511 Capital Building Stabilization Project
IOWA CITY, IOWA
10271-10004

ADDENDUM 01
November 24, 2025

This addendum forms a part of the Contract Documents and modifies the original bidding documents dated November 14, 2025, as noted below.

7 ROOF DETAIL - MECHANICAL CURB DETAIL
1 1/2" = 1'-0"

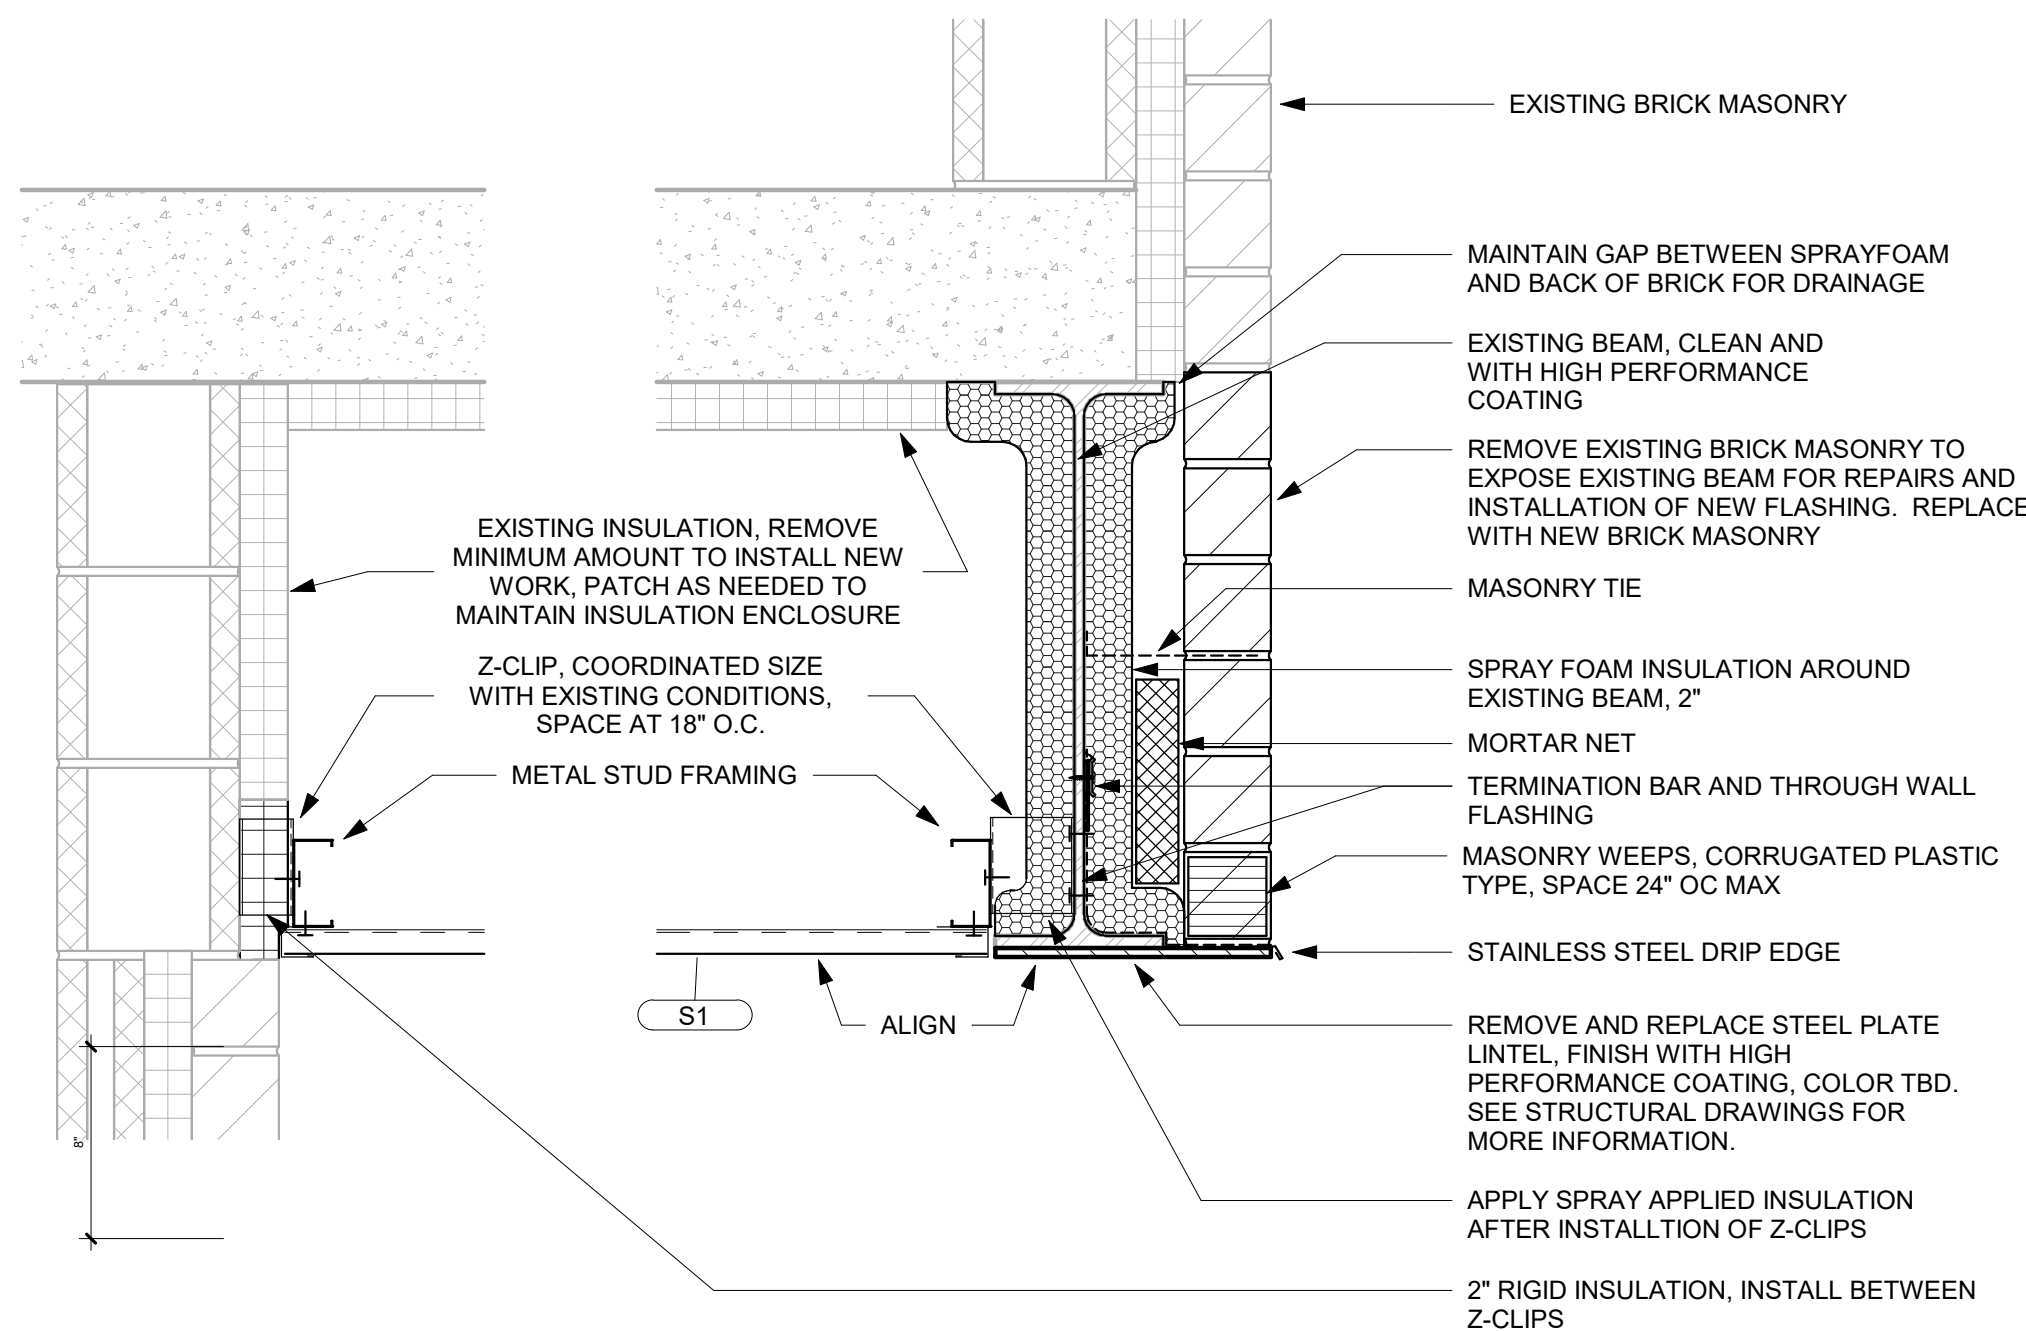
| A1-2 | Drawing A501 – DETAILS <ol style="list-style-type: none">1. REVISED Detail 7 |

ROOF MECHANICAL PLAN
1/8" = 1'-0"

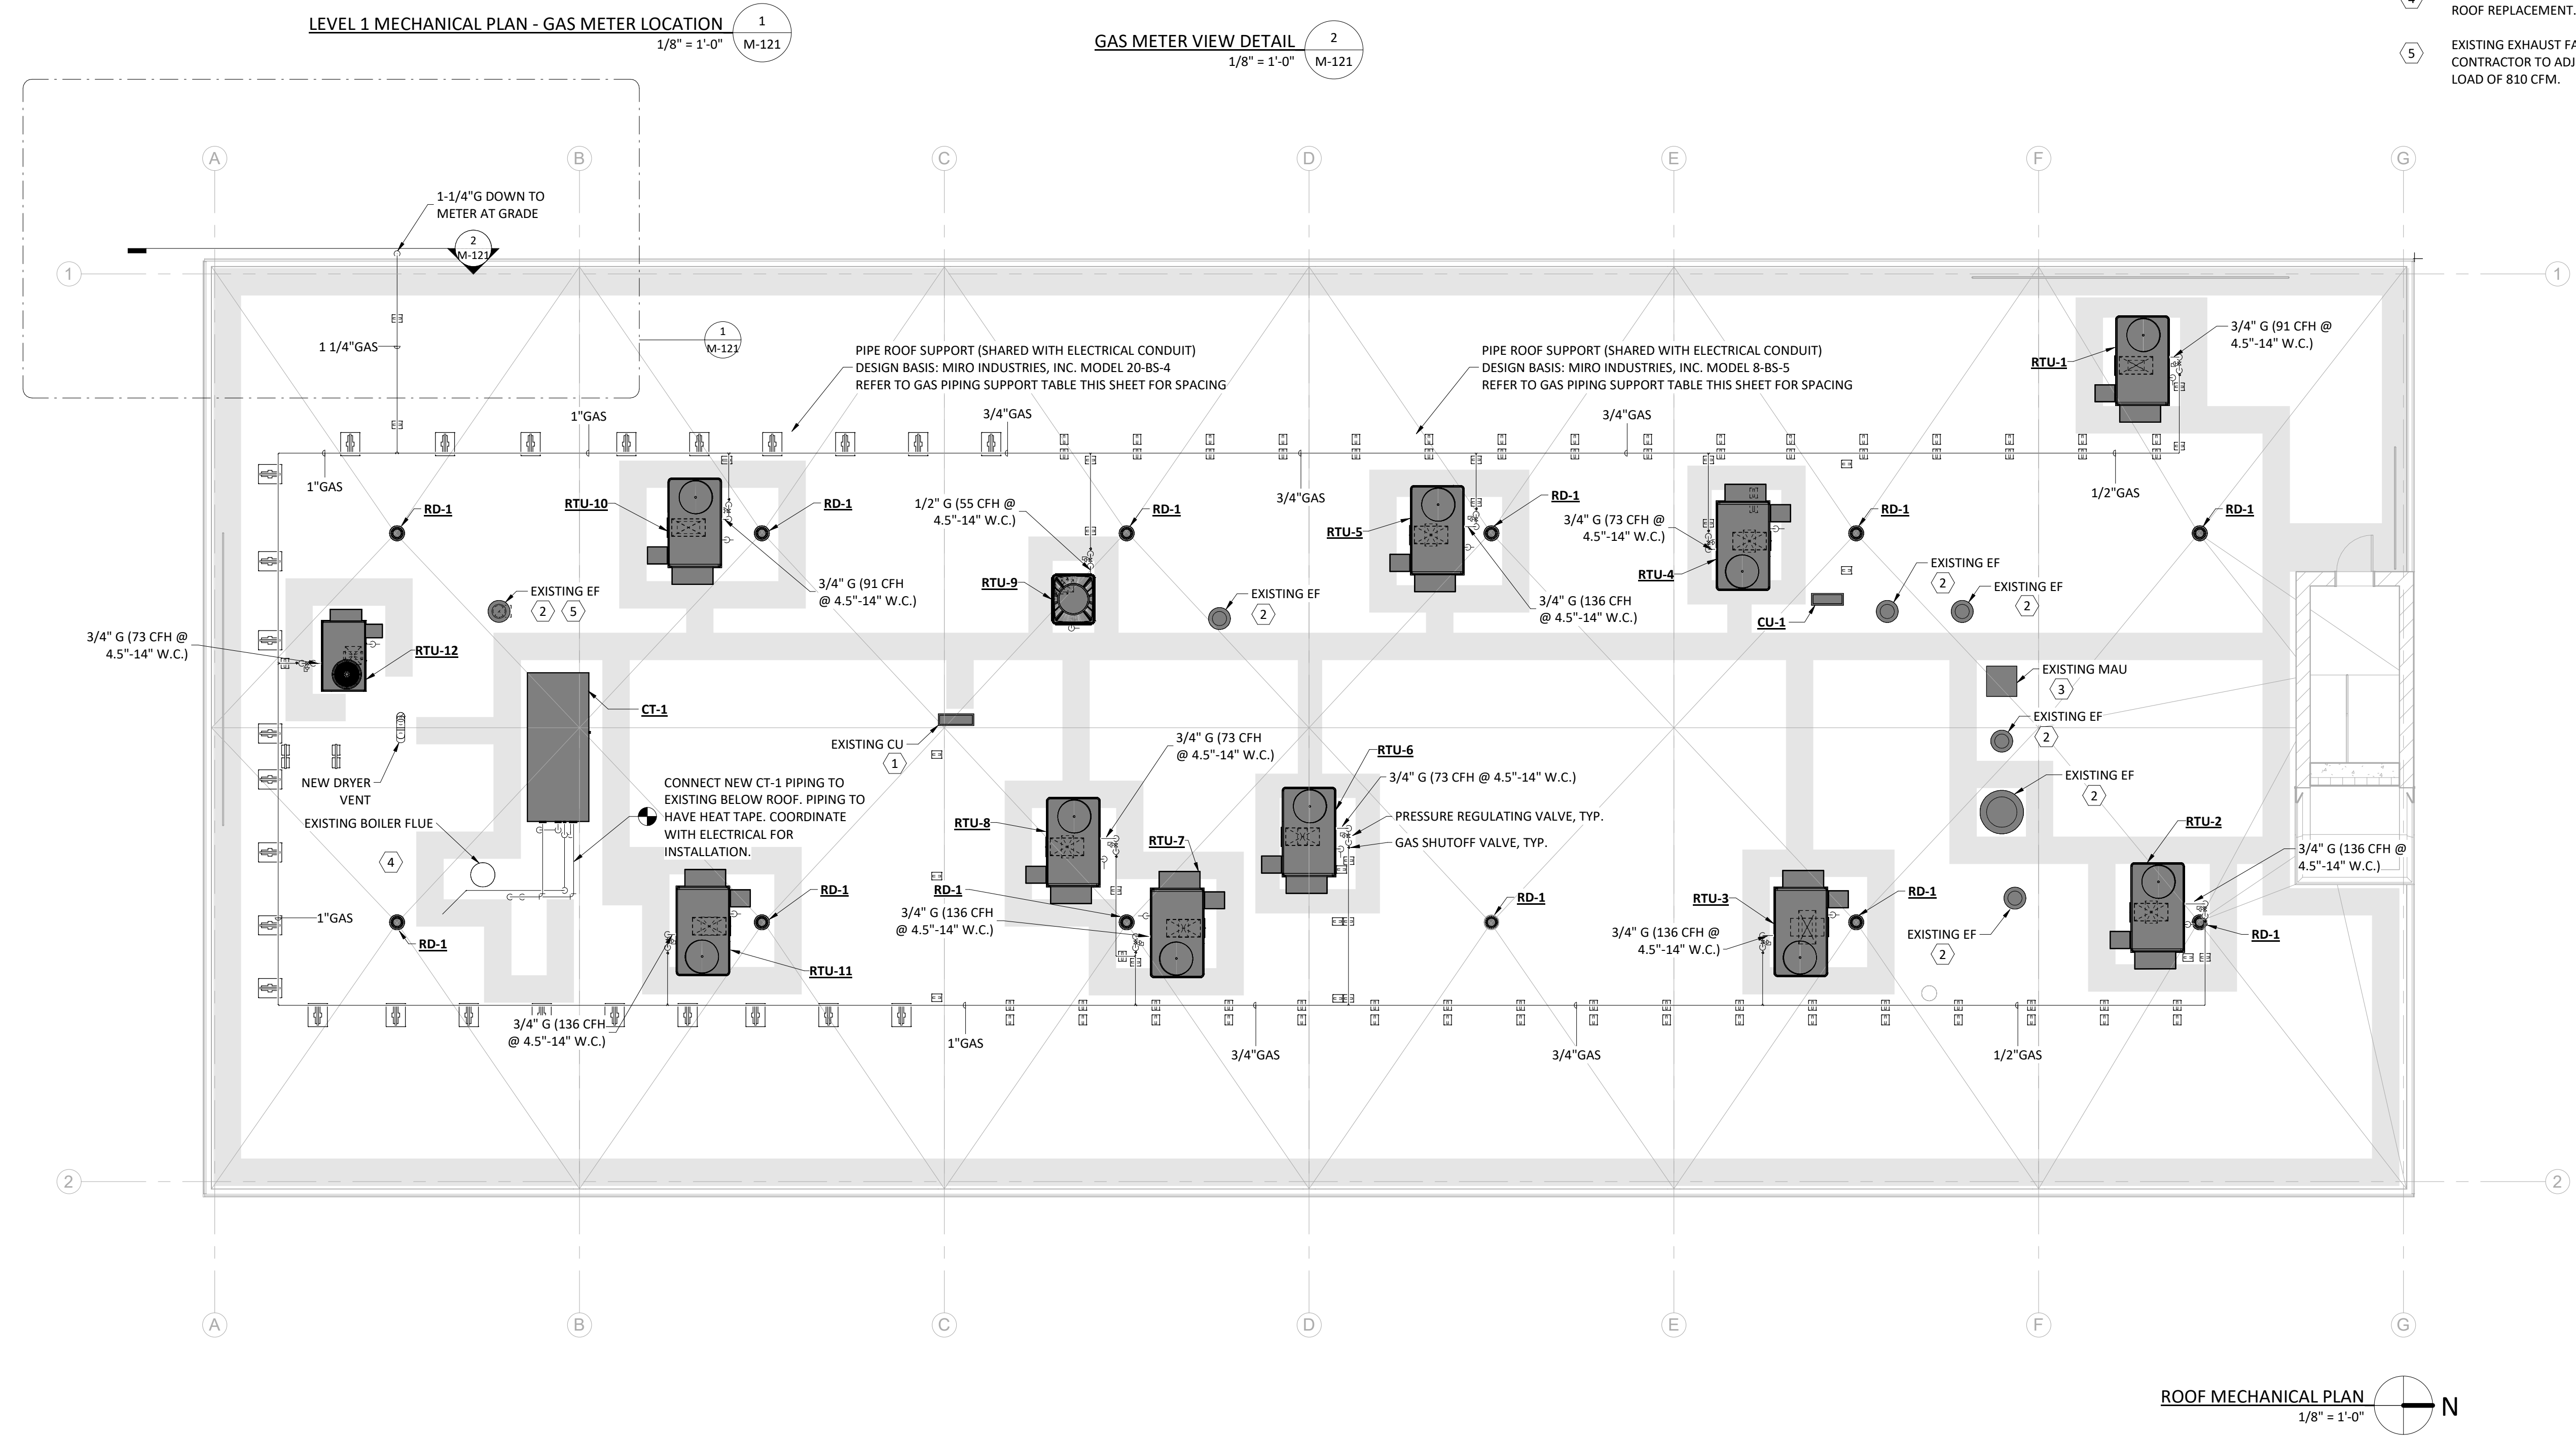
| M1-1 | Drawing M-121 – ROOF MECHANICAL PLAN <ol style="list-style-type: none">1. REVISED Rooftop Unit roof curb note. |

- COORDINATE NEW RTU LOCATION WITH EXISTING OPENINGS THROUGH ROOF. NEW RTUS SHALL BE PROVIDED WITH NEW ROOF CURBS.
 - COORDINATE LOCATION OF ROOFTOP EQUIPMENT WITH ALL VENTS.
